Title: TOP & POWER

Project: NUCLEO-XXXXXXX			
Size: A4	Reference: MB1136	Revision: C.3	
Date: 9/26/2014		Sheet: 1 of 4	life.augmented

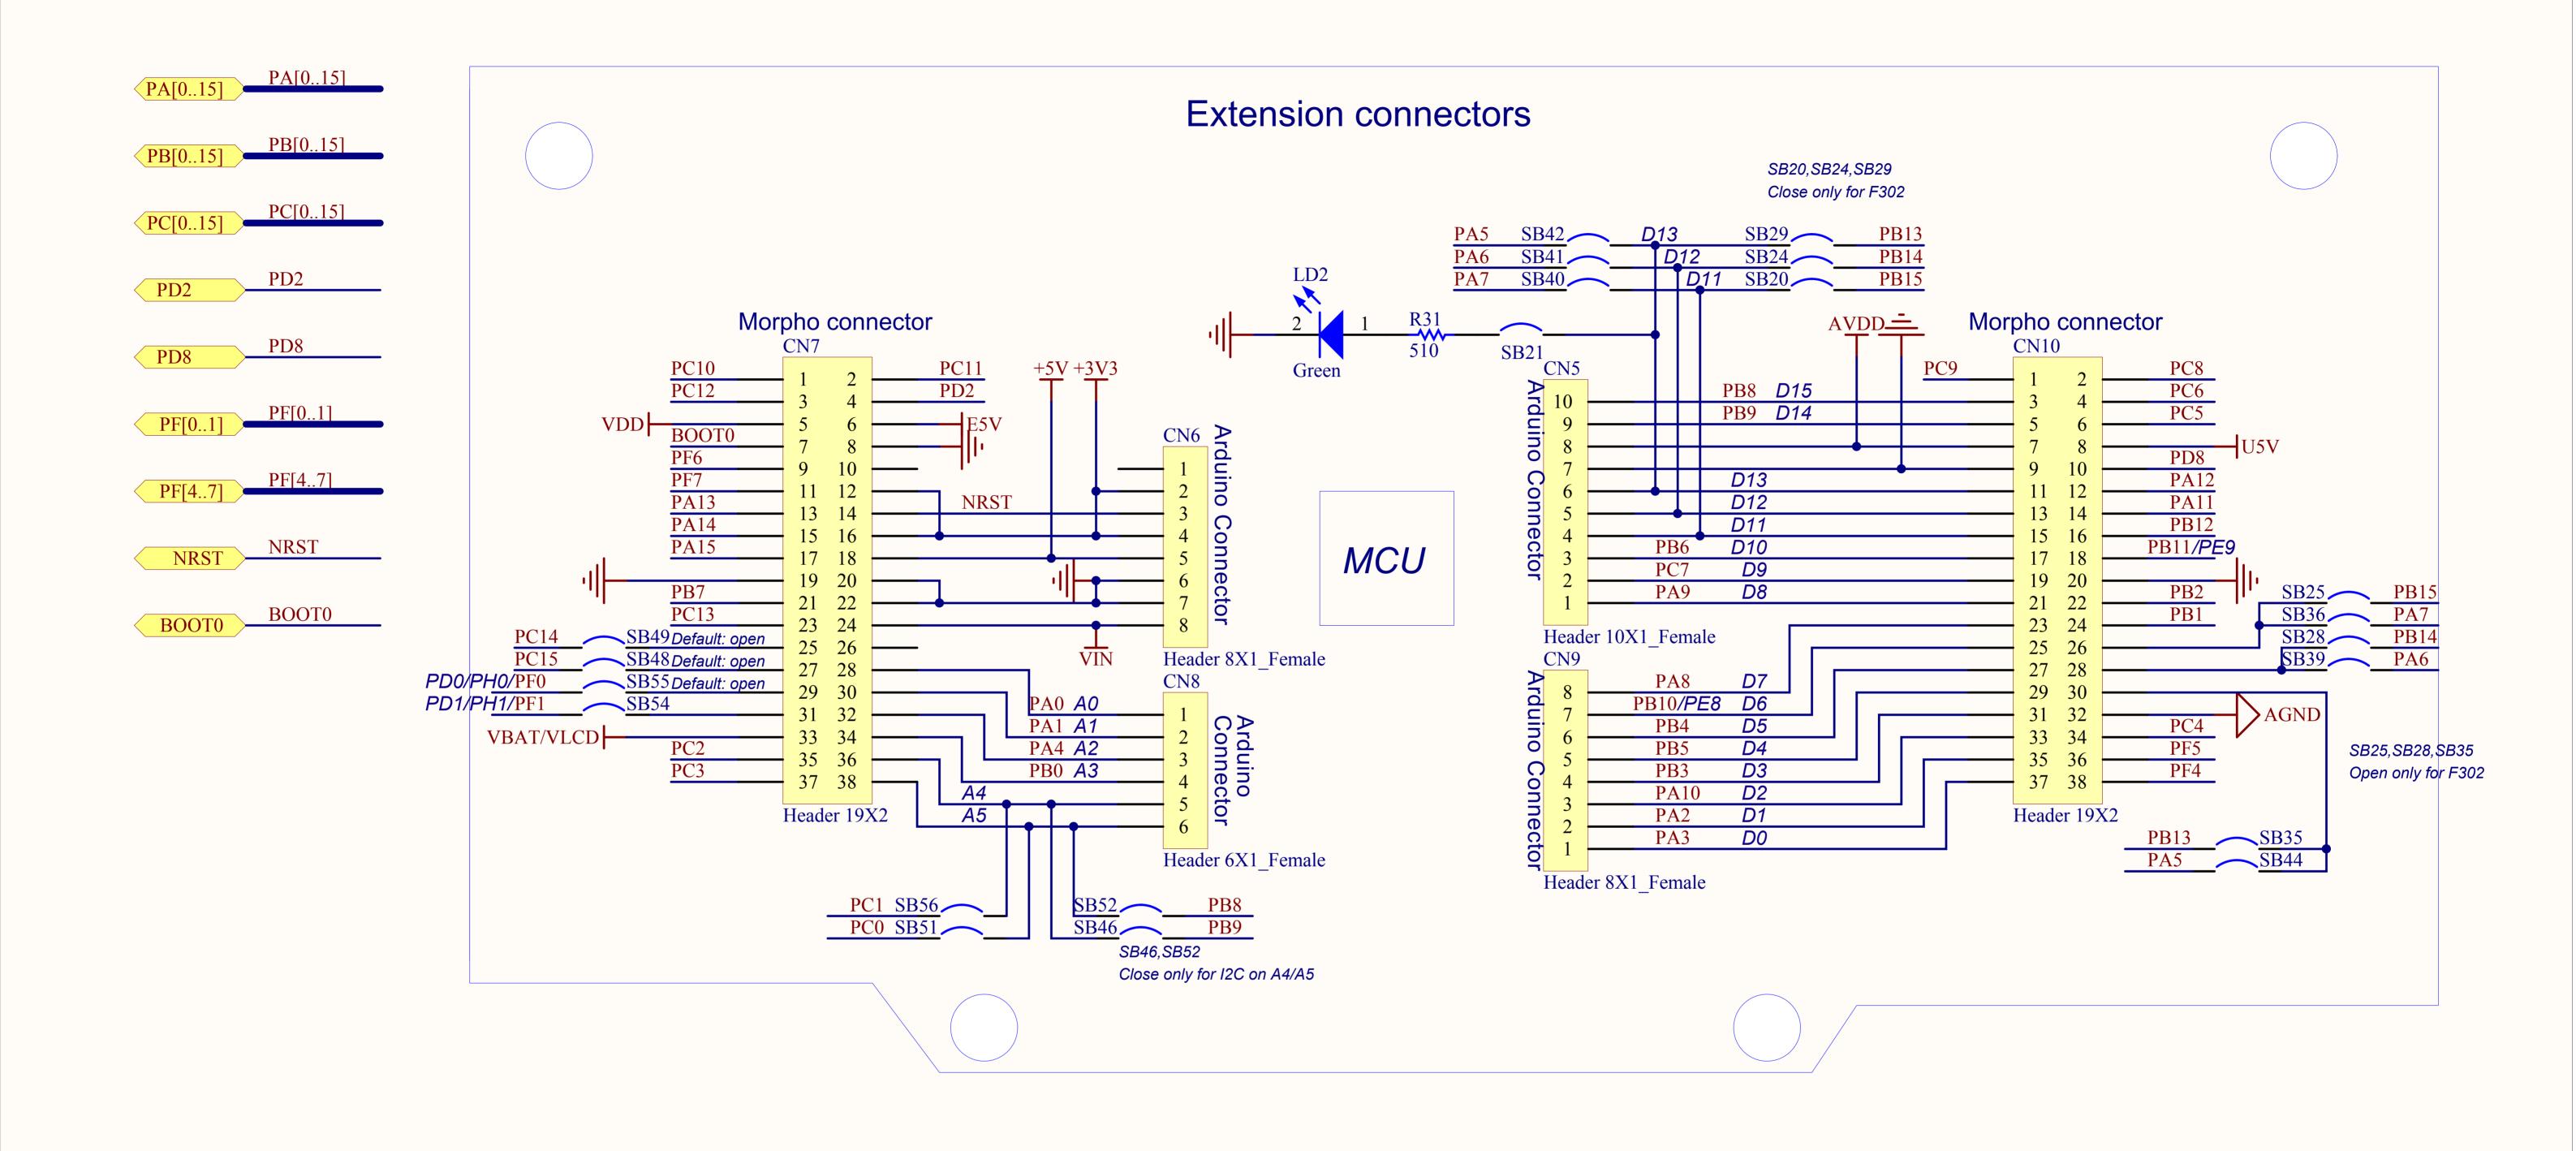
Note2: Remove [N/A] on R34, R36, C31, C32, X2 from C.1 to C.2

Note3: Add "default open" on SB48, SB49, SB55 from C.1 to C.2

Note4: Replace "default open" by "default closed" on SB16 & SB50 from C.1 to

Note5: C31&C32 value changed from 10pF to 4.3pF to fit with new 32K crystal ABS25-32.768KHZ-6-T
